STATE OF CONNECTICUT CONNECTICUT SITING COUNCIL

DOCKET NO. 416 D/B/A VERIZON WIRELESS FOR A

RESPONSES OF CELLCO PARTNERSHIP d/b/a VERIZON WIRELESS TO CONNECTICUT SITING COUNCIL PRE-HEARING INTERROGATORIES, SET ONE

Migratory Bird Impact Evaluation Proposed Verizon Wireless Facility

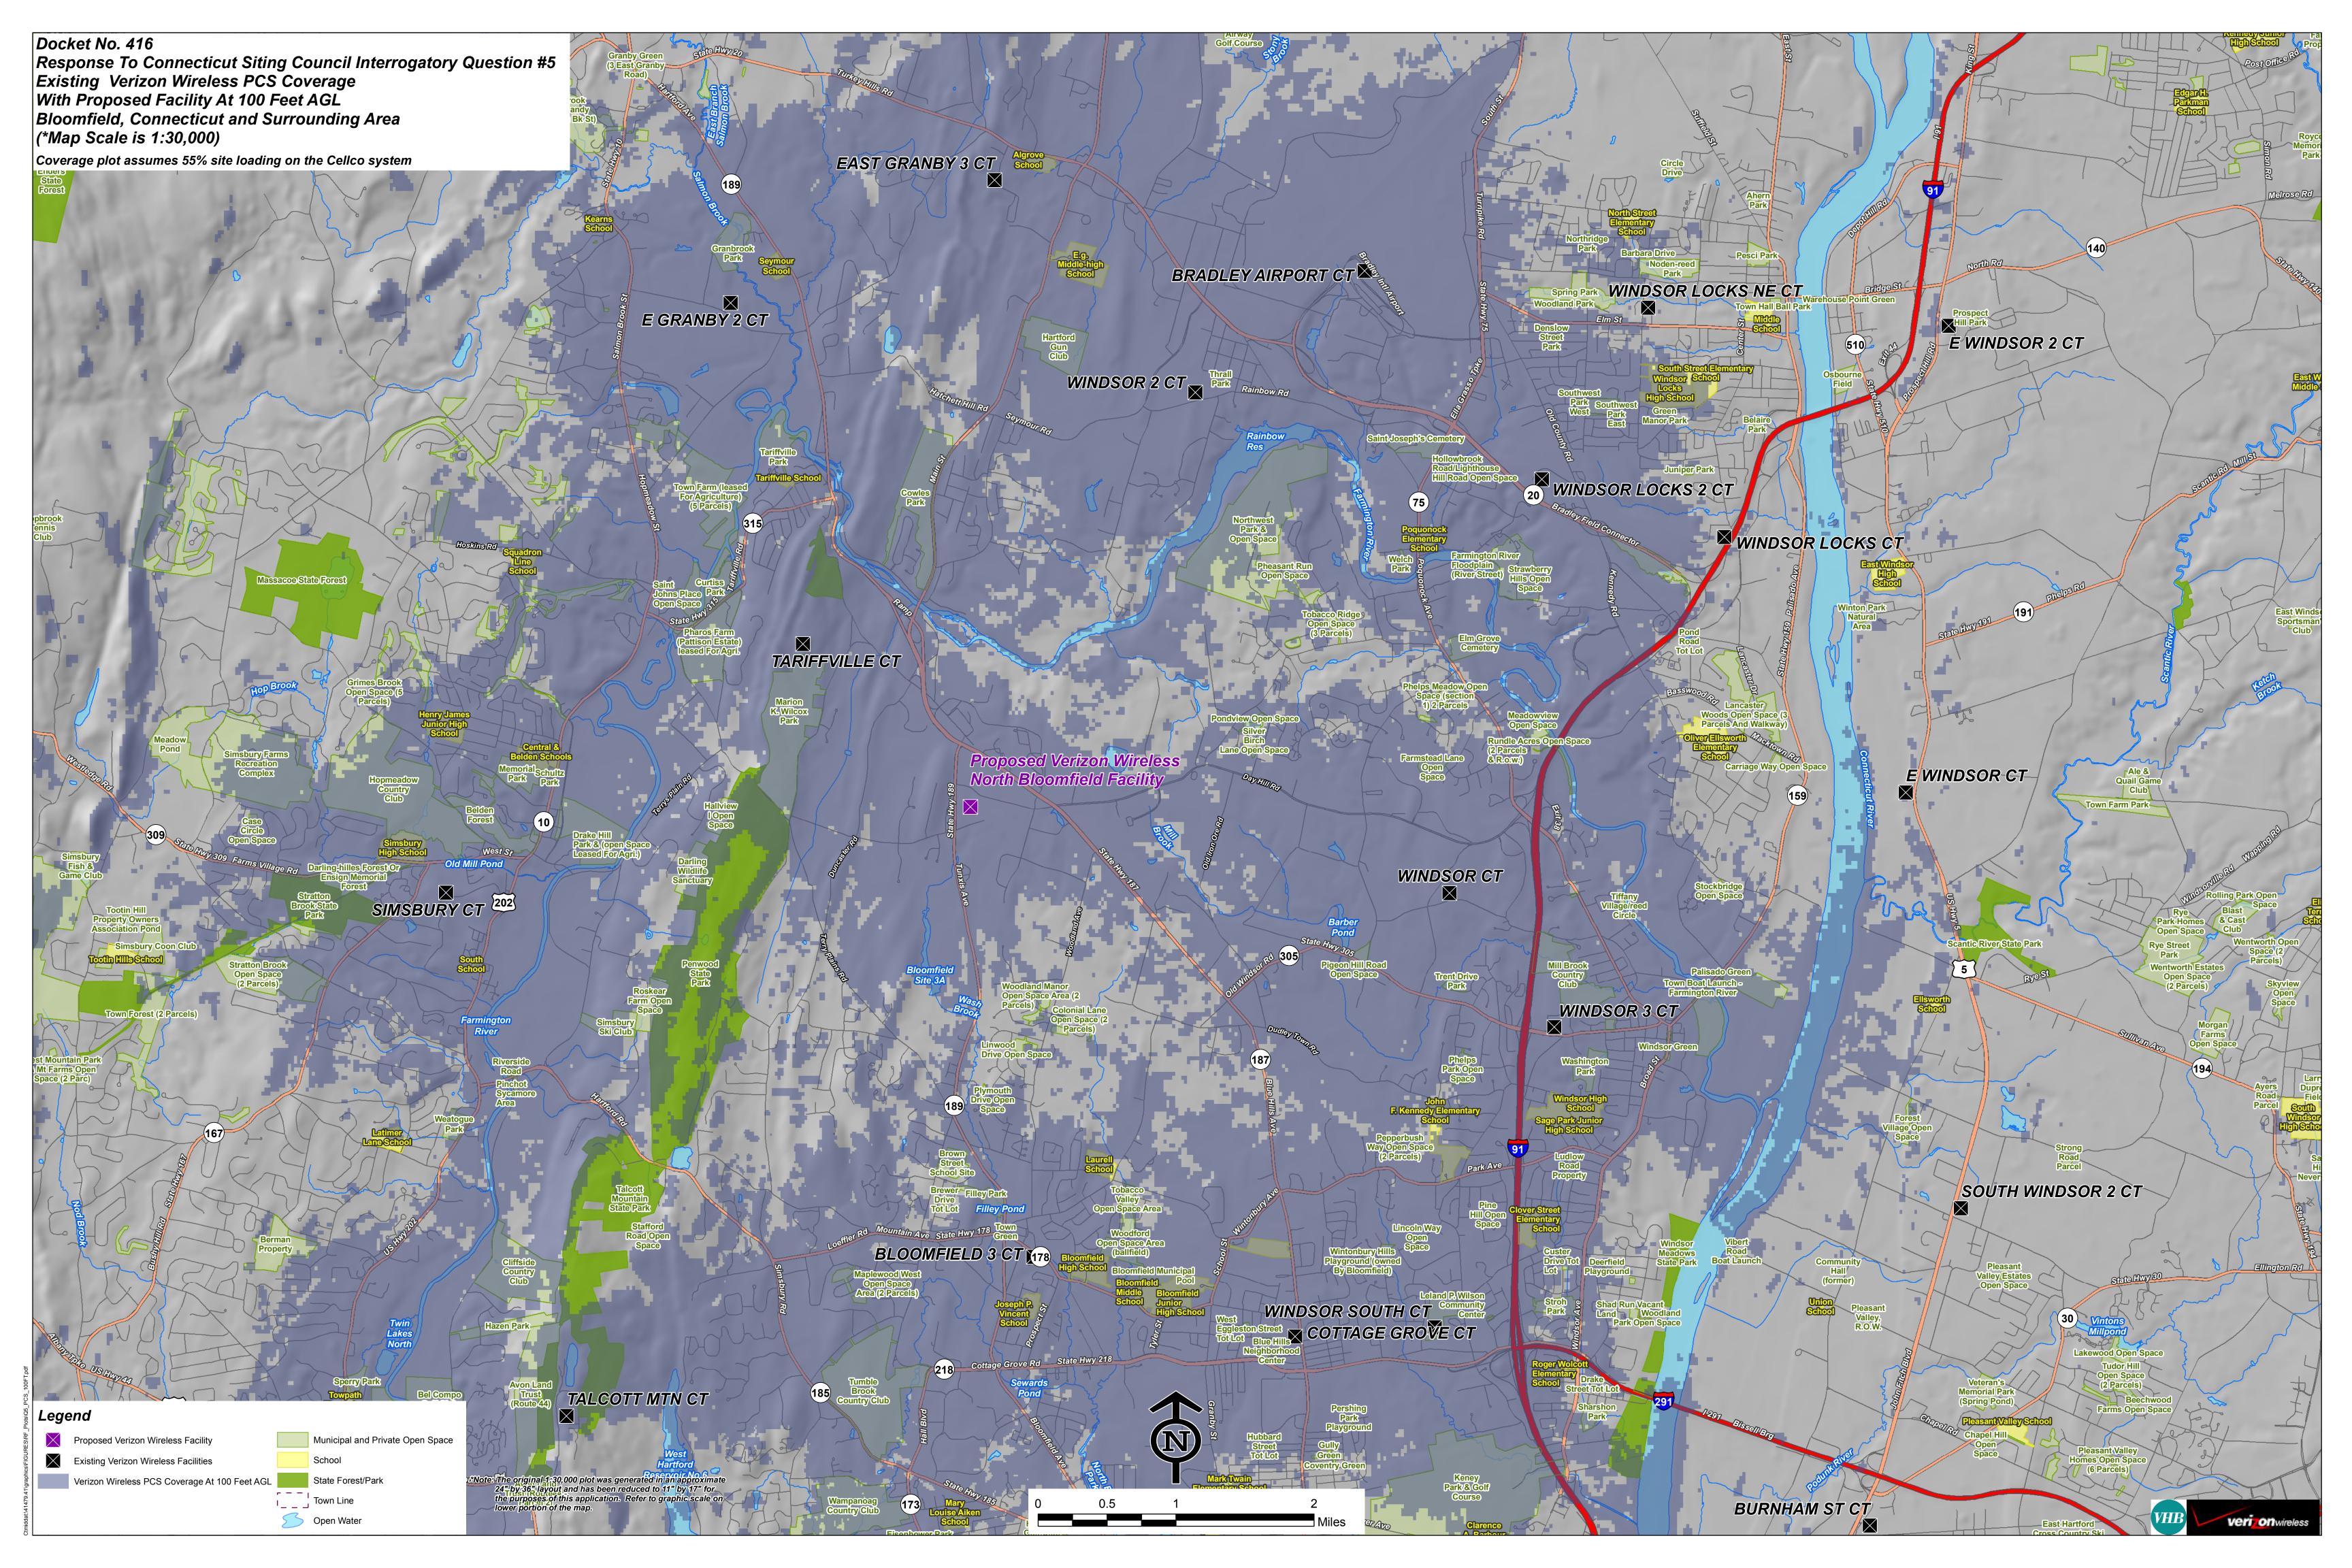
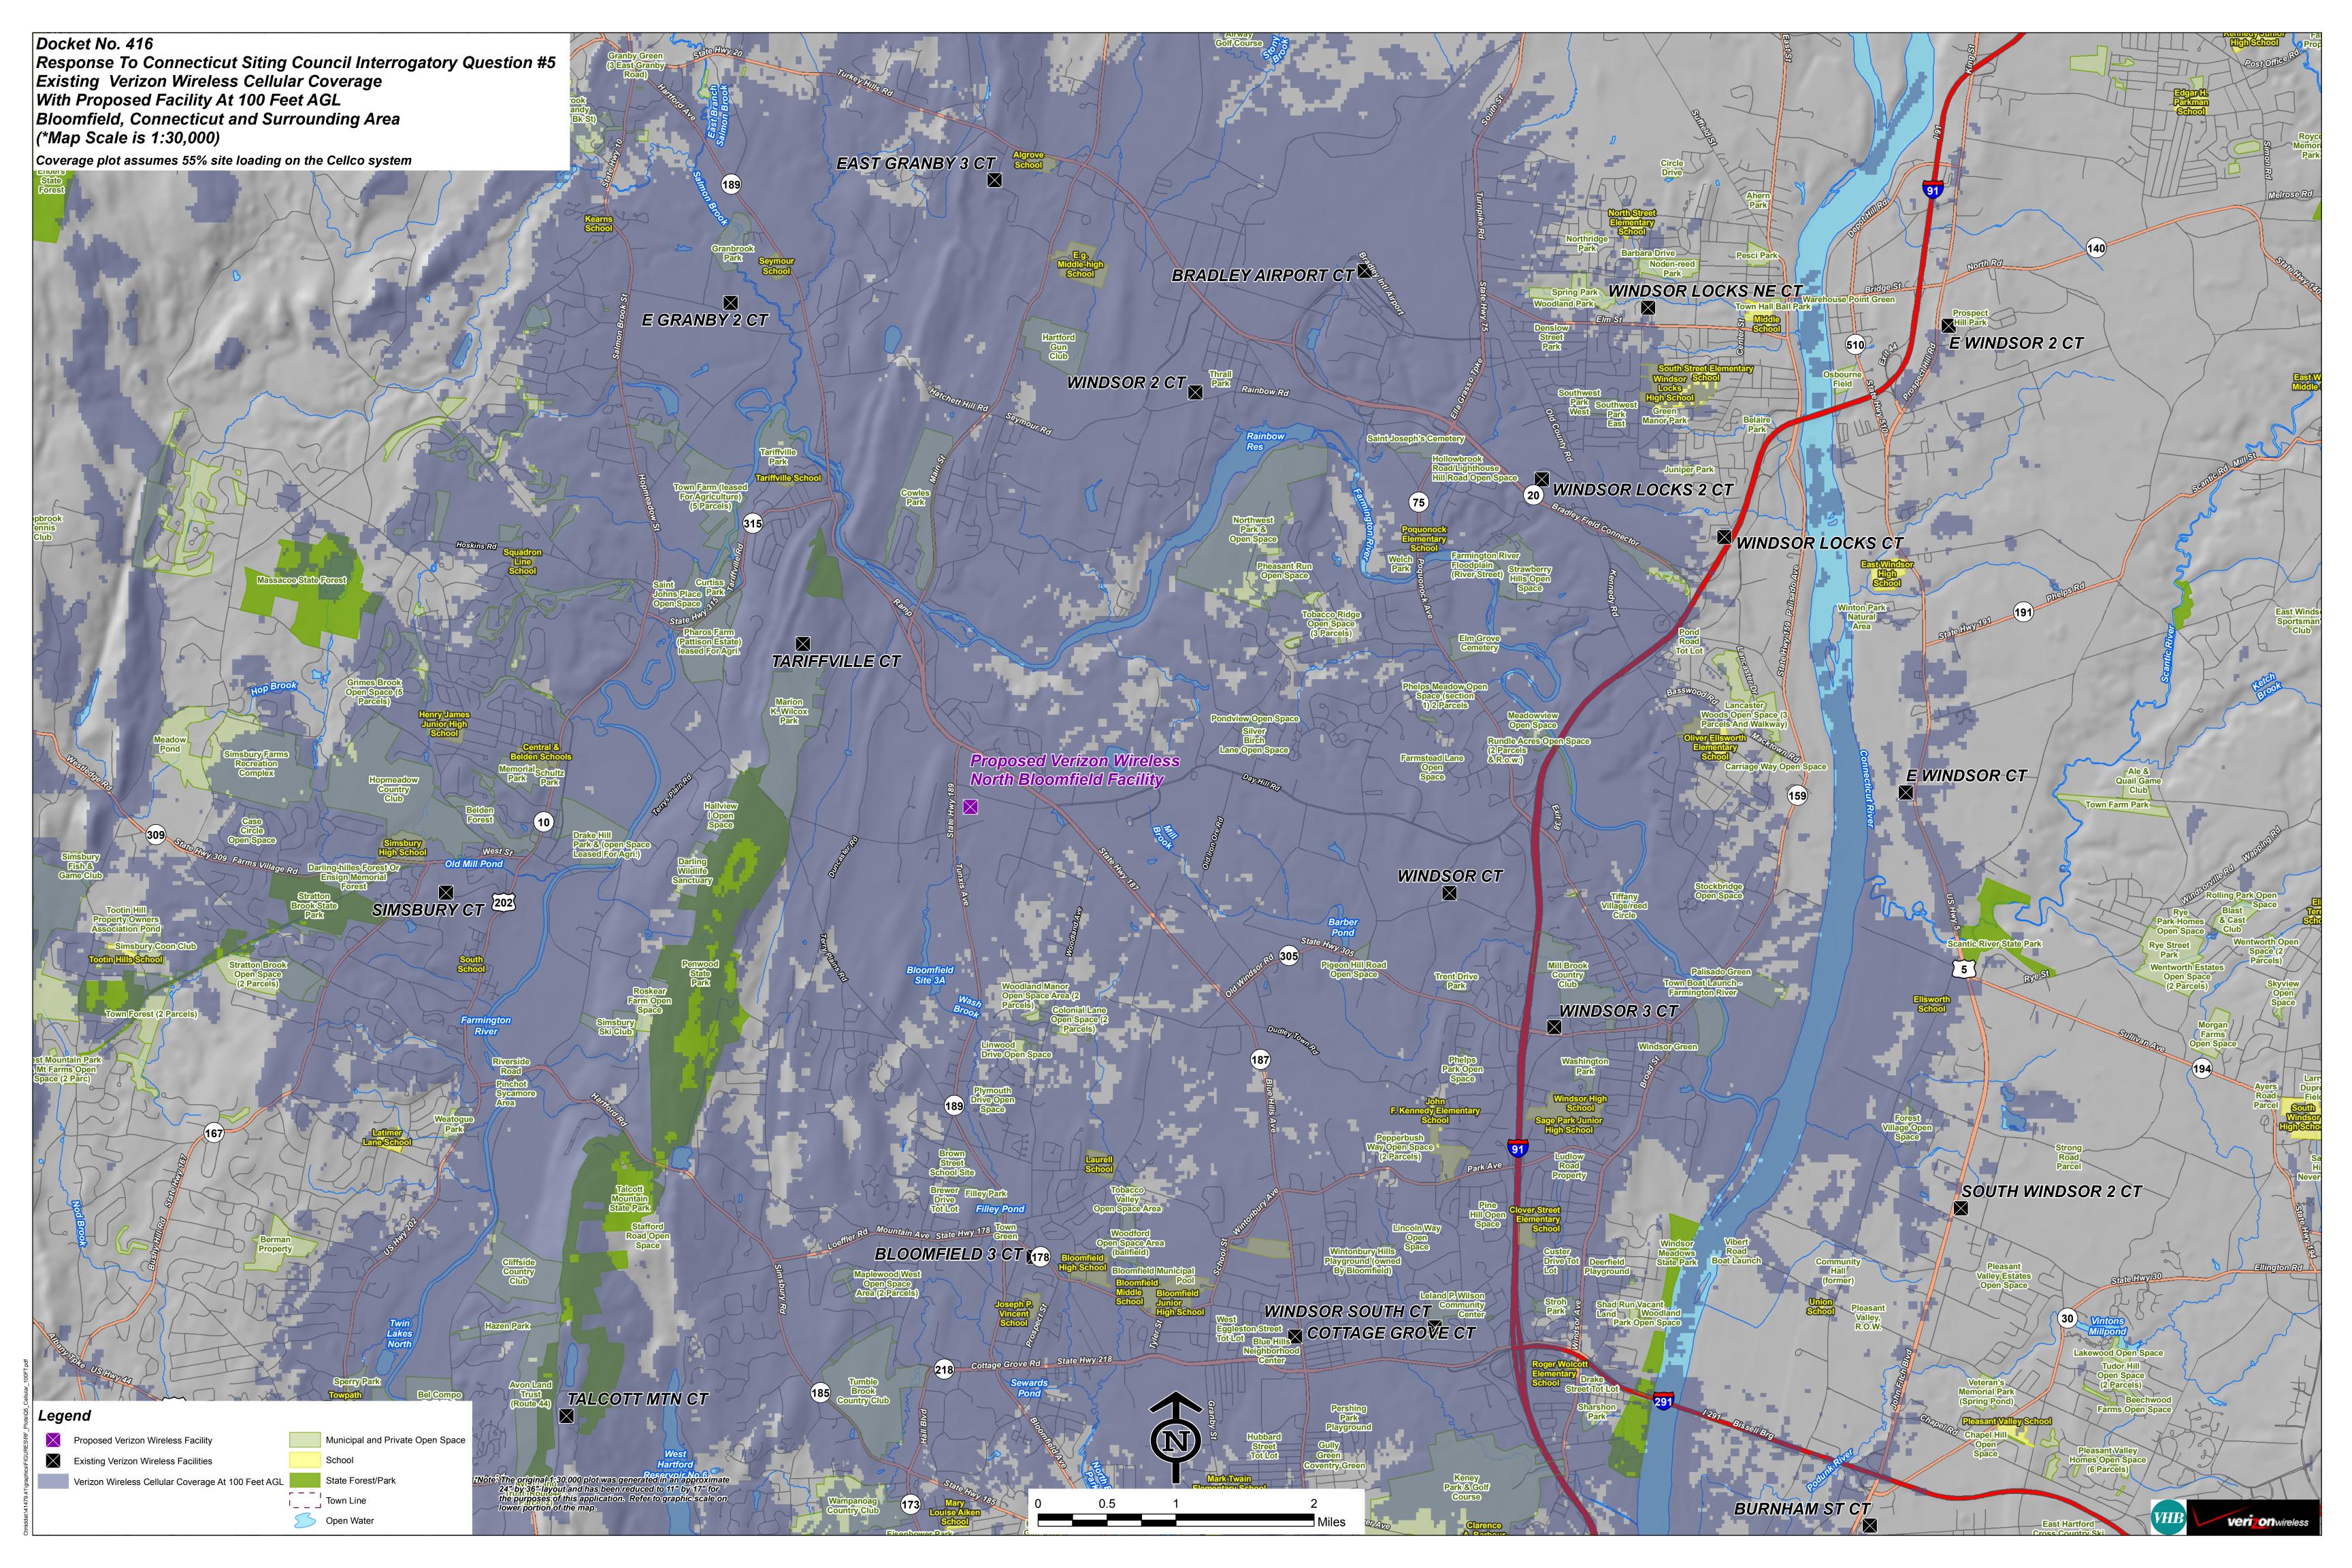
What is the lowest height at which Cellco's antennas could achieve its coverage objectives from this site? Submit propagation maps showing the coverage at ten feet below this height.

Cellco has determined that the 110-foot level is the minimum antenna height needed to satisfy its North Bloomfield coverage objectives. Plots showing Cellco's coverage at 100' are included behind <u>Tab 1</u>. At 100', Cellco's coverage footprint shrinks from 4.07 to 3.35 square miles at 850 MHz frequencies; 3.88 to 3.52 square miles at 1900 MHz frequencies; and 5.91 to

5.25 square miles at 700 MHz frequencies.
